**CITY OF BOULDER**  
**PLANNING BOARD AGENDA ITEM**  
**MEETING DATE: August 20, 2015**

**AGENDA TITLE:** Public hearing and consideration of Site and Use Review applications for redevelopment of an approximately 1.34-acre site located at 2440 and 2490 Junction Place within Boulder Junction. Referred to as “The Commons,” the proposed commercial development would consist of two, 3-4 story, 55’ tall buildings totalling roughly 100,000 sq. ft. that would include professional office space, restaurant space and “flex” space intended as community gathering space. The proposal also includes 56 underground parking spaces, a proposed “mobility hub” that includes a car share program and B-Cycle Station, a central public plaza area and multiple multi-modal connections through the site. The project is reviewed under two separate case no. LUR2015-00048 (Site Review) and LUR2015-00065 (Use Review, required for proposed restaurant over 1,500 sq. ft. in size).

Project Name: The Commons  
Location: 2440 & 2490 Junction Pl.  
Size of Tract: 1.34 acres (58,272 sq. ft.)  
Zoning: Mixed Use – 4  
Comprehensive Plan: Mixed Use Business

**Figure 9: Excerpt from TVAP Connections Plan showing connections through the site**

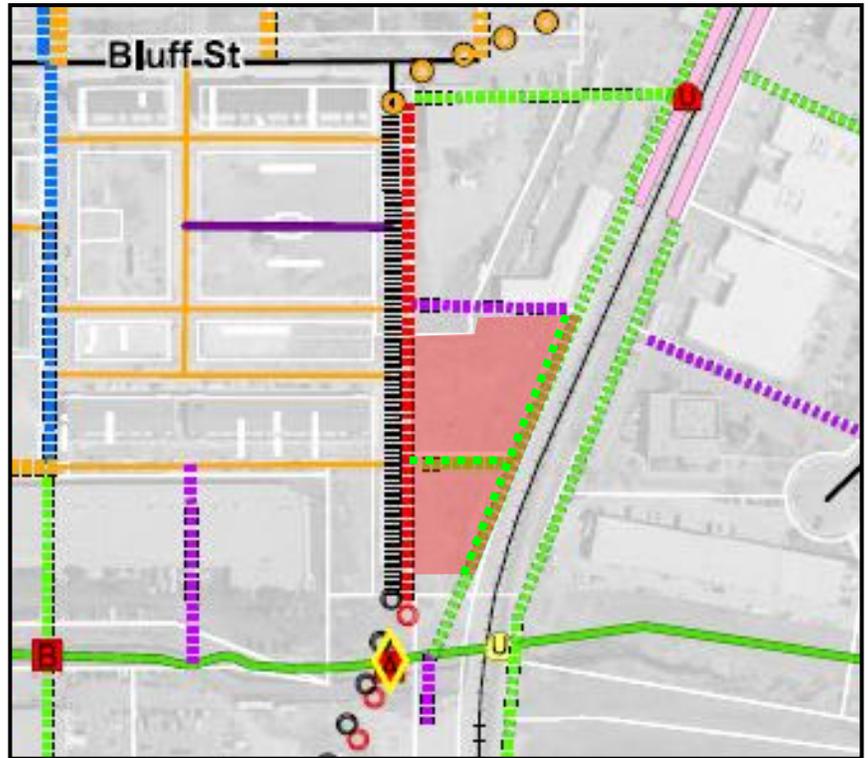
**TVAP Connections Plan.** As shown on the TVAP connections plan and in **Figure 9** above, a 12’ wide multi-use path is anticipated along the west side of the tracks to access the rail platform, as well as a connecting E-W multi-use path generally along the lot line between the two parcels. The current proposal includes construction of both of the required multi-use paths. The proposal is also consistent with the Streetscape Guidelines in TVAP, which illustrate the anticipated layout of Junction Place from the Bus Facility in Depot Square to Bluff Street. This streetscape is described as “Segment 2” within the streetscape guidelines on Pg. 37 of TVAP as follows:

Figure 10: Illustrations comparing TVAP street section (left) with proposed project street section (right)

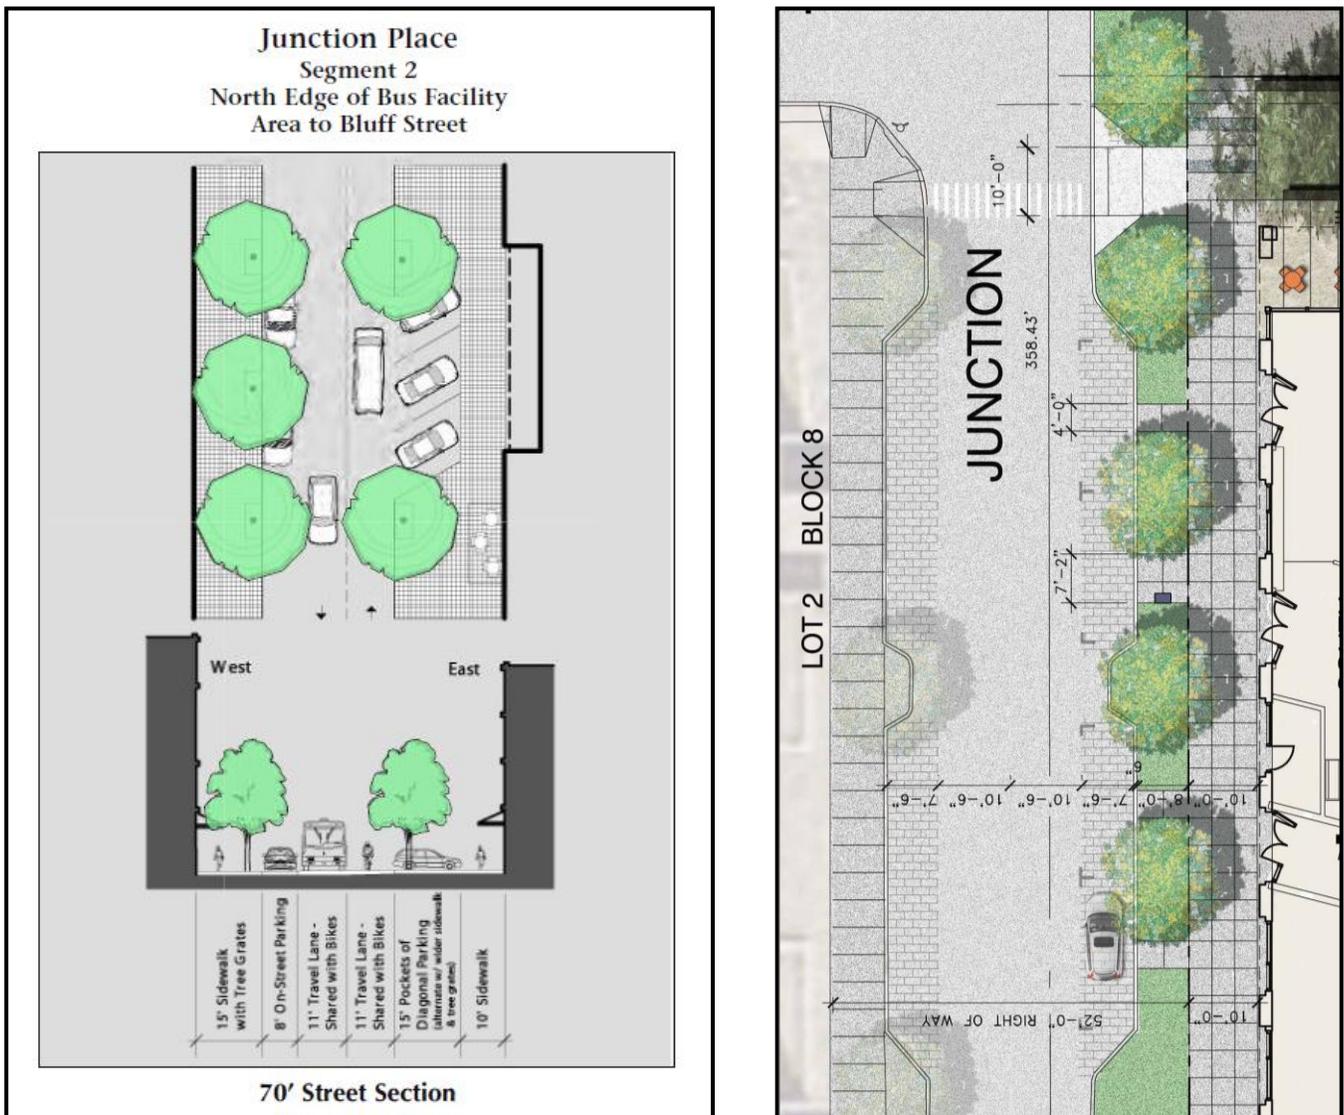
As shown in **Figure 10**, the proposed Junction Place street section includes the following cross-sectional design elements, consistent with the street section requirements included in TVAP:

- 10' 6" Travel Lane (reduction from 11' as shown in TVAP approved by staff)
- 15' 6" combined on-street parking and landscape width (city staff has determined that parallel parking is preferred over the diagonal configuration shown in TVAP).
- 10' sidewalk
